APPROVAL <i>Slw</i>	REQUEST FOR COUNCIL ACTION	MEETING DATE 10/03/17
REPORTS & RECOMMENDATIONS	RESOLUTION IMPOSING CONDITIONS AND RESTRICTIONS FOR THE APPROVAL OF A SPECIAL USE FOR A CONDOMINIUMS DEVELOPMENT USE UPON PROPERTY LOCATED AT 9733 SOUTH 76TH STREET (NEUMANN DEVELOPMENTS, INC., APPLICANT)	ITEM NUMBER <i>G.2.</i>
<p>At its September 21, 2017 meeting the Plan Commission recommended approval of a resolution imposing conditions and restrictions for the approval of a special use for a condominiums development use upon property located at 9733 South 76th Street (Neumann Developments, Inc., Applicant).</p> <p>As discussed at the Plan Commission meeting, staff revised the draft resolution to include a condition requiring that the developer shall enter into a Development Agreement with the City of Franklin, prior to the issuance of a Building Permit.</p> <p style="text-align: center;">COUNCIL ACTION REQUESTED</p> <p>A motion to adopt Resolution No. 2017-_____, a resolution imposing conditions and restrictions for the approval of a special use for a condominiums development use upon property located at 9733 South 76th Street (Neumann Developments, Inc., Applicant).</p>

REPORT TO T

Park Circle Exterior Lighting

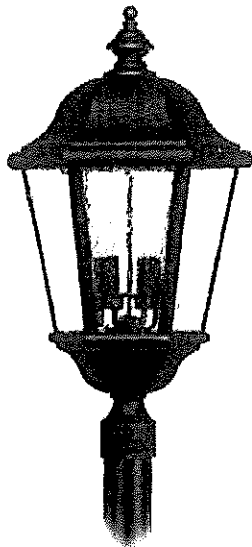
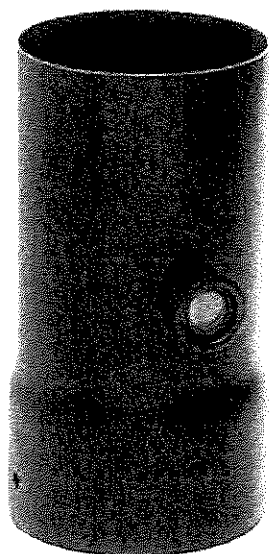
18. Pursuant to Section 15-7.0103W. of the UDO, please provide a Lighting Plan. Please note that a preliminary plan is to be submitted at the time of initial application filing, with the later submission of a final plan as a condition of any approvals, if the Plan Commission makes a determination that this is reasonably necessary.

30. Pursuant to Sections 15-5.0401, 15-5.0402, and 15-5.0404 of the UDO, please verify that the exterior lighting standards have been met.

See attached lighting plan.

Please see the attached lighting plan.

Master Landscape Concept

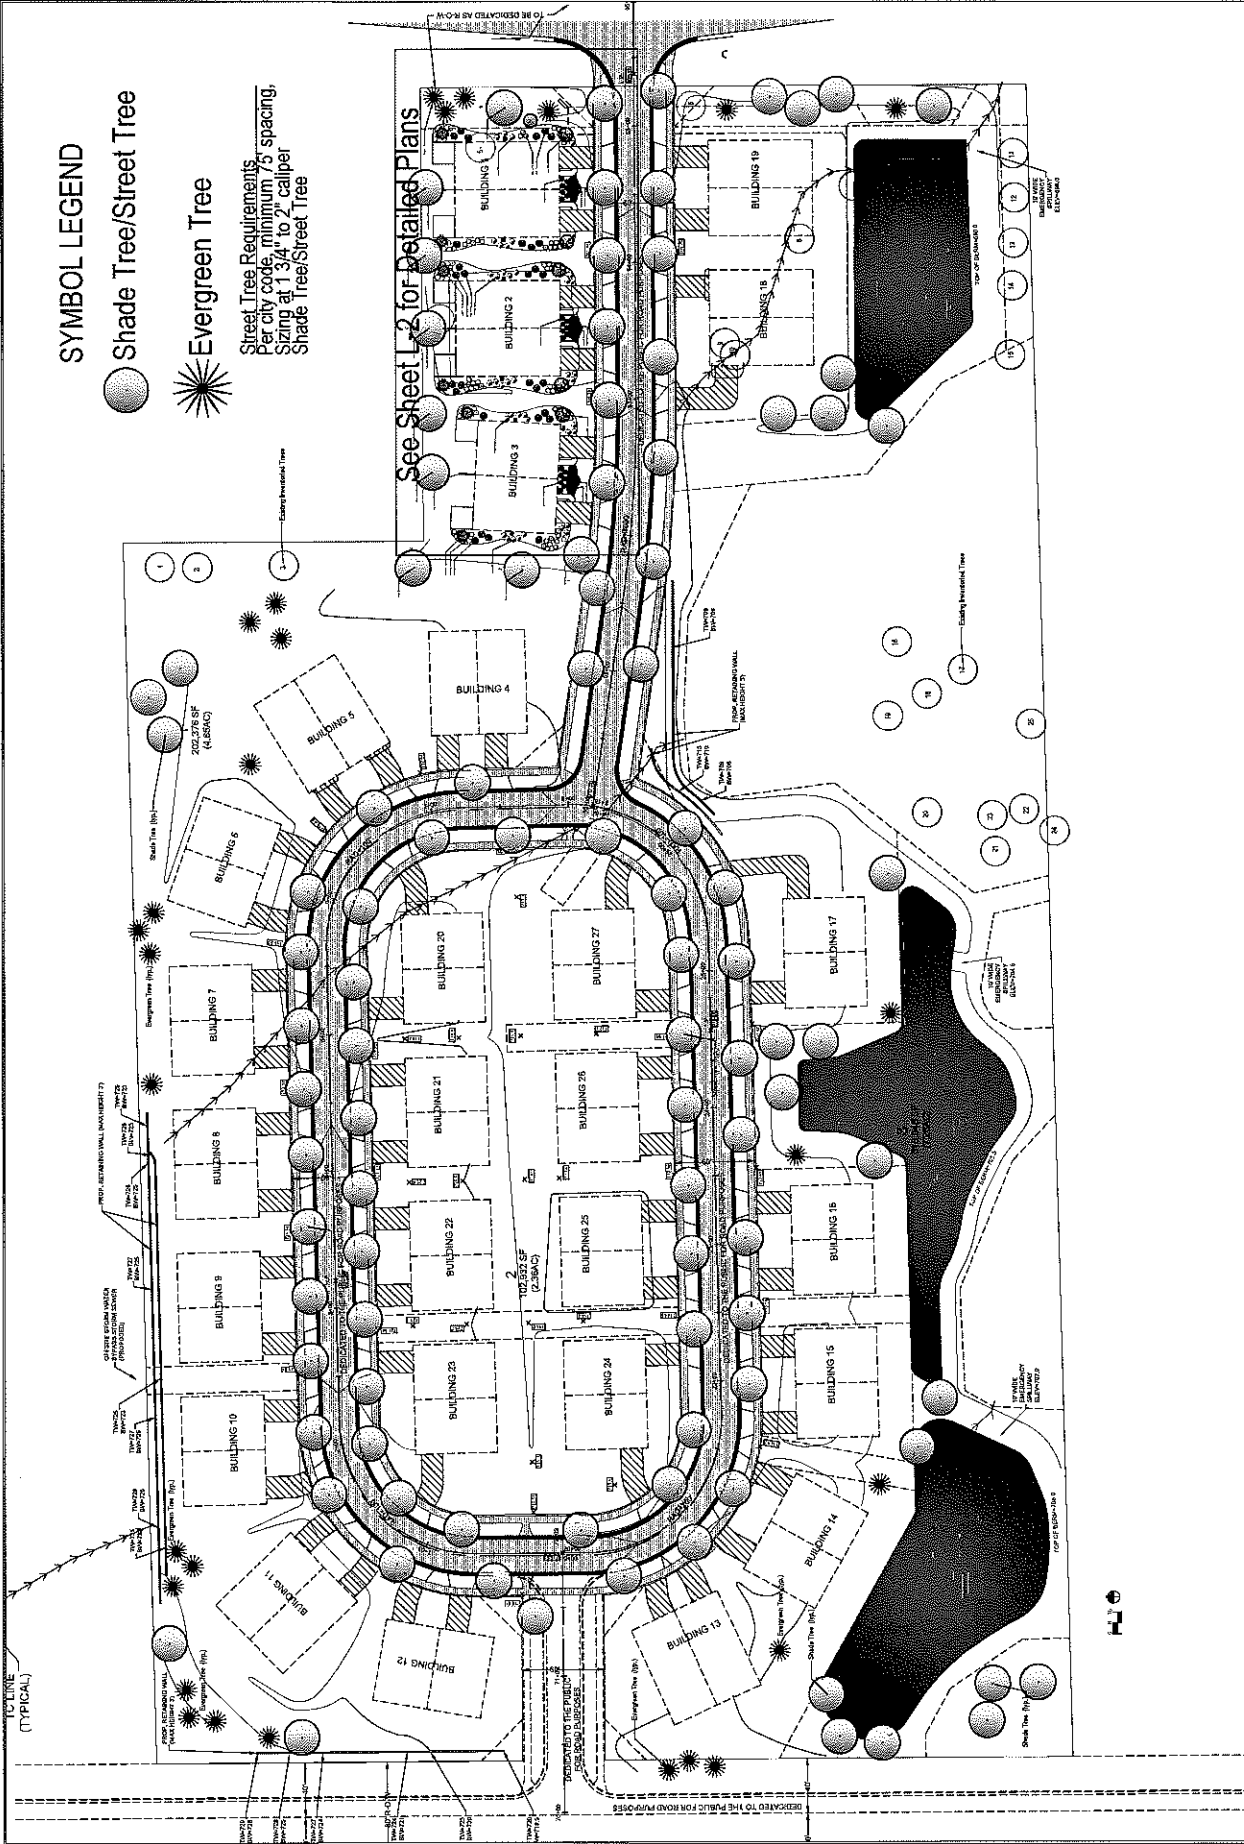
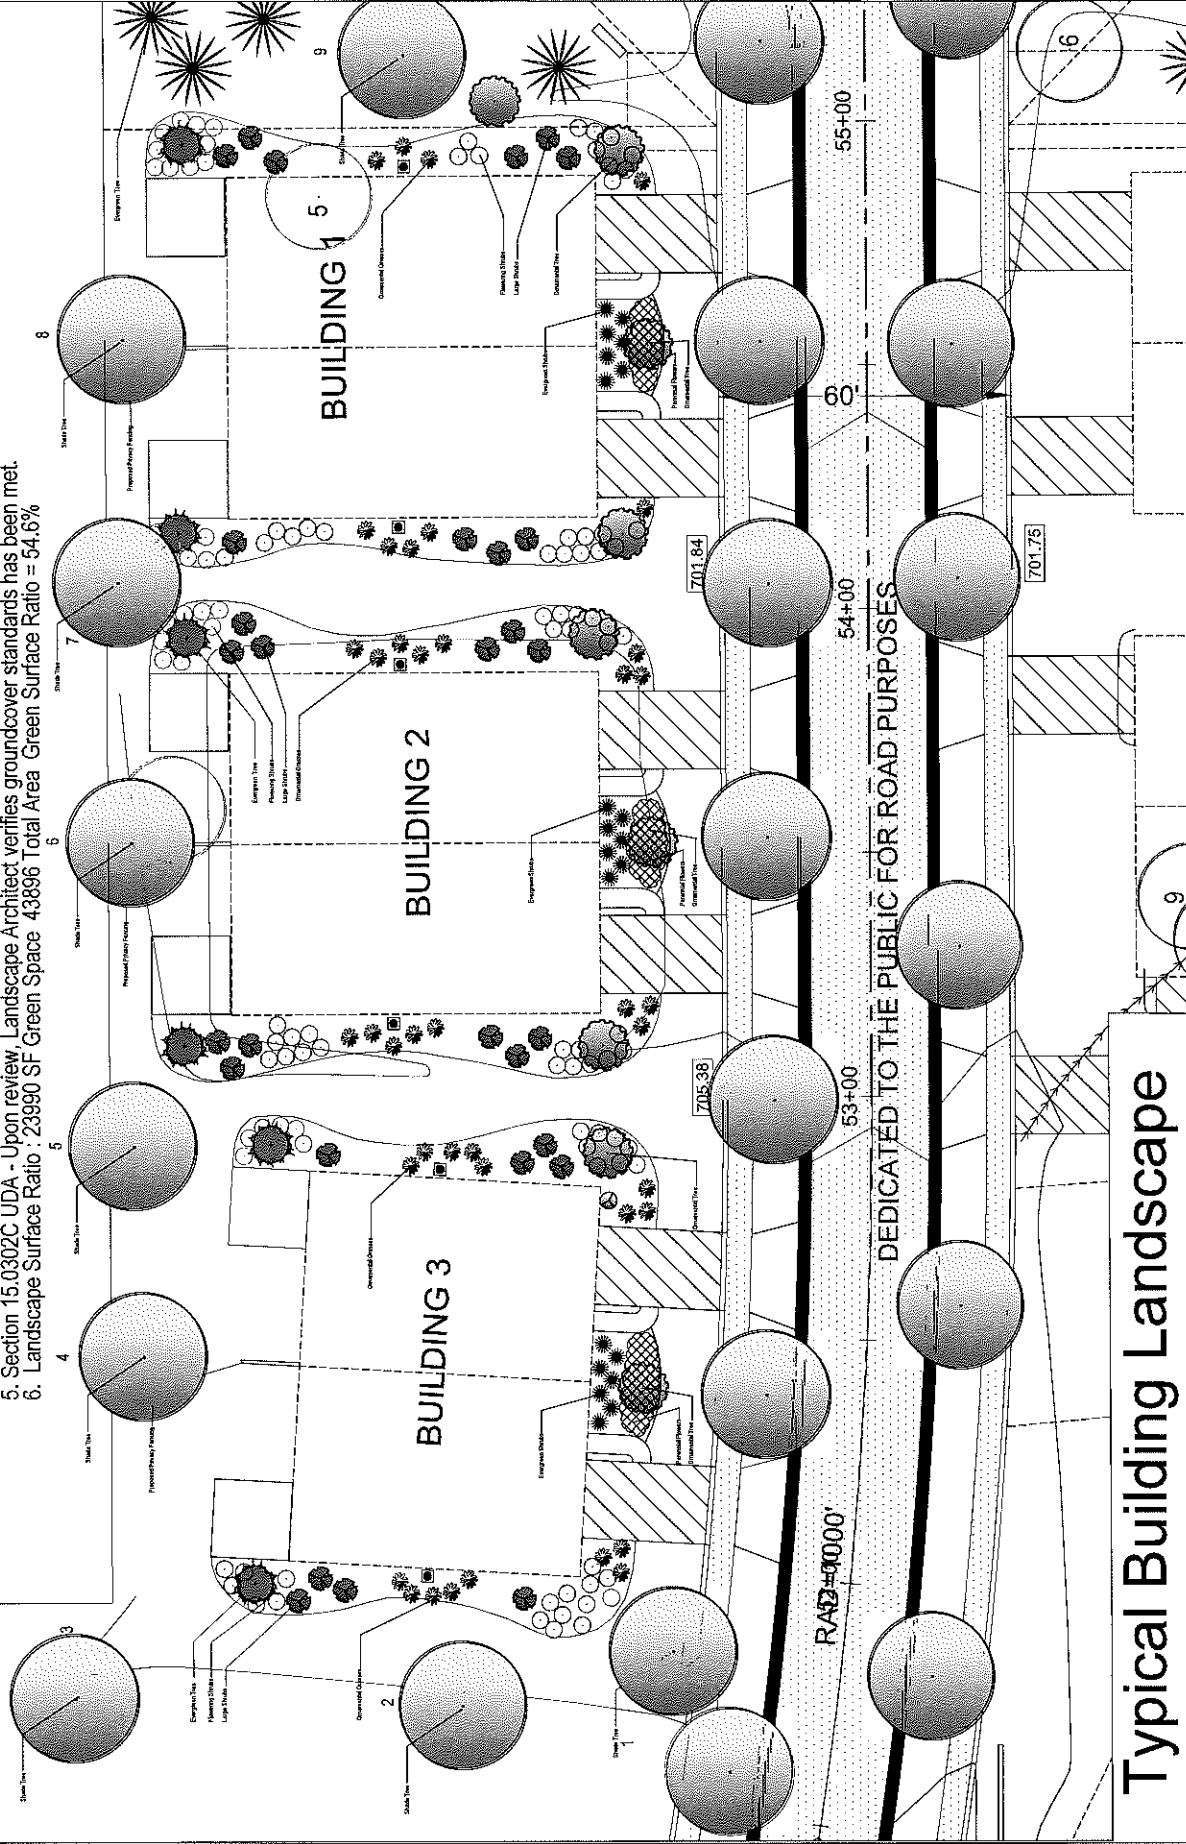
14. Pursuant to Section 15-7.0103R. of the UDO, staff recommends that additional landscaping (for buffers/screening for the three adjacent homes) be reflected on the preliminary Landscape Plan that was submitted. Please note that a preliminary plan can be submitted at the time of initial application filing, with the later submission of a final plan as a condition of any approvals, if the Plan Commission makes a determination that this is reasonably necessary.

22. Pursuant to Section 15-5.0302A. of the UDO, please verify that the standard plant units are being met, and include that information on the Landscape Plan.

23. Pursuant to Section 15-5.0302C. of the UDO, staff suggests that the minimum quantity of landscape plantings be increased by 20 percent and the additional plants primarily located adjacent to the three existing homes.

27. Pursuant to Section 15-5.0302I. of the UDO, please revise the Landscape Plan to include the following information: the preparer's name; existing plantings to be preserved, the Landscape Surface Ratio; a planting schedule; and calculations showing that the City's minimum quantity standards have been met.

See attached landscape plan.

Please see revised landscape plans

Please see revised landscape plans

Please see revised landscape plans
